**SUBJECT: MCGUIRE NUCLEAR STATION, UNIT 1 – RELIEF 09-MN-002, REVISION 1,
FOR A PROPOSED ALTERNATIVE TO DELAY THE UPDATE TO THE CODE
OF RECORD FOR THE FOURTH 10-YEAR INSERVICE INSPECTION (ISI)
INTERVAL (TAC NO. ME4870)**

SAFETY EVALUATION BY THE OFFICE OF NUCLEAR REACTOR REGULATION

REPAIR OF BURIED SERVICE WATER PIPING

RELIEF NO. 09-MN-002, REVISION 1

Figure 1 (Example of Code-Compliant Repair)

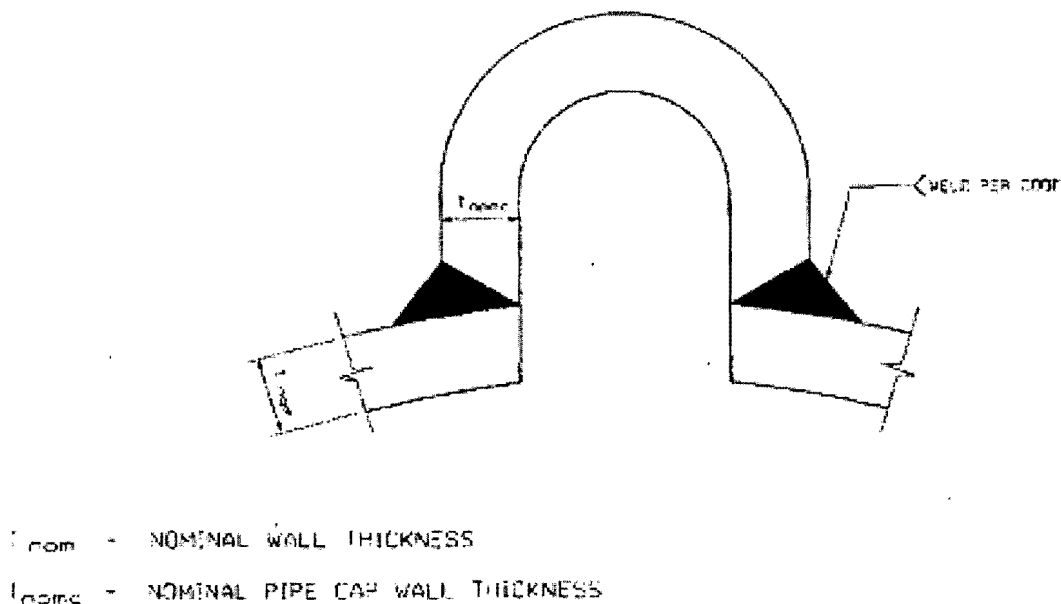
If unacceptable wall thinning is found during the course of an inspection of either the excavated RN LLI or the SNSWP piping, the licensee is required to repair the unacceptable area.* One possible configuration of a Code-compliant repair, where the defect is removed and a new pressure retaining boundary is formed, is shown in Figure 1. In order to perform such a repair, the pipe would have to be isolated, depressurized, drained and the repair would have to be performed, pressure-tested, and examined prior to returning the pipe to service. These activities would have to be performed within the 72-hour allowed outage time for TS 3.7.7, Condition A. If Condition A cannot be met within the 72-hour allowed outage time, both units would need to be in Mode 3 within 6 hours and Mode 5 within 36 hours. The NRC staff concurs with the licensee that isolation, depressurization, draining, defect removal, repair, testing and examination within the 72 hours is difficult. The NRC staff finds that a mid-cycle shutdown of one unit in order to perform a Code-compliant repair would present a hardship.

The NRC staff notes the general design similarity to a Code-compliant repair, Figure 1. The NRC staff finds that the proposed design has several advantages over the Code-compliant repair of Figure 1. First, the application of corrosion protection within the encapsulation after pressure testing inhibits corrosion on the interior of the encapsulation as well as the remaining pipe wall within the bounds of the encapsulation. In addition, the remaining pipe wall material, while performing no structural function, provides an additional corrosion allowance in comparison to the design configuration of the Code-compliant repair (Figure 1). The NRC staff concludes that the proposed alternative encapsulation design is acceptable.
